UNITED STATES PATENT AND TRADEMARK OFFICE

APPLICATION NO.	FILING DATE	FIRST NAMED INVENTOR	ATTORNEY DOCKET NO.	CONFIRMATION NO.
10/041,833	10/19/2001	David Laverne Sprinkle	DEE6270P0160US	5412

Office Action Summary

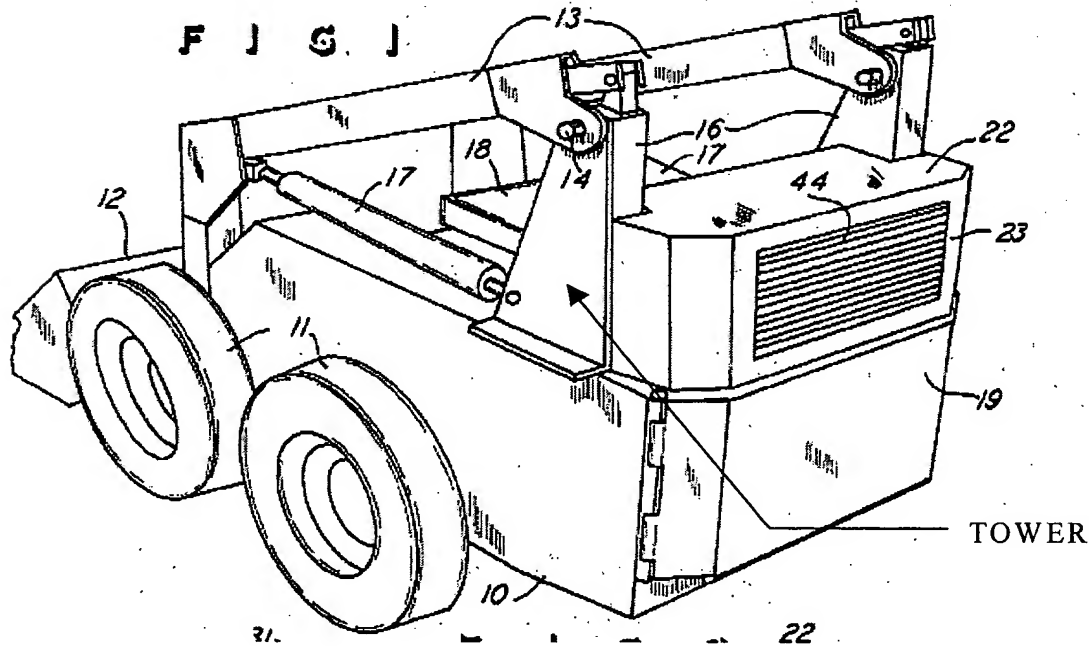
Klee teaches a utility vehicle comprising:

a chassis (10) supported on wheels (Figure 1);

a loader bucket (12);

a pair of towers (see sketch on next page) supported on said chassis and extending substantially vertically (Figure 1), said towers shaped to have outside edges that are further apart

at a bottom thereof an closer at a top thereof (note base of towers on Figure 1 have outside edges that are further apart); and

a pair of boom arms (13) pivotally connected (14) at base ends thereof to a top of each tower, respectively.
